**G-05501-R1**  
**April 2005**

**SUBJECT: SAFETY RECALL (CANADA, EXPORT)**  
**FRONT DRIVE SHAFT on 4800 4x4's with FABCO**  
**TC-200 TRANSFER CASES built 6/30/1999 thru**  
**5/8/2002**

*This Recall is the final remedy and supercedes Safety Recall G-03516*

### **REVISION DESCRIPTION**

**Figure 9 – Rotated Air Dryer**

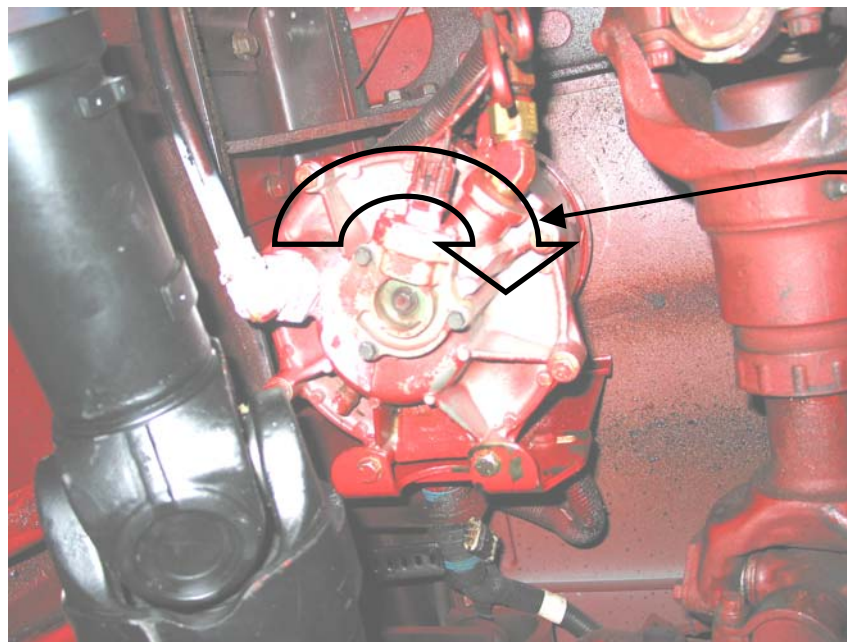
17. Rotate air dryer and re-install mounting bolts; tighten strap bolts.

**NOTE: Please only rotate one (1) mounting bolt position.**
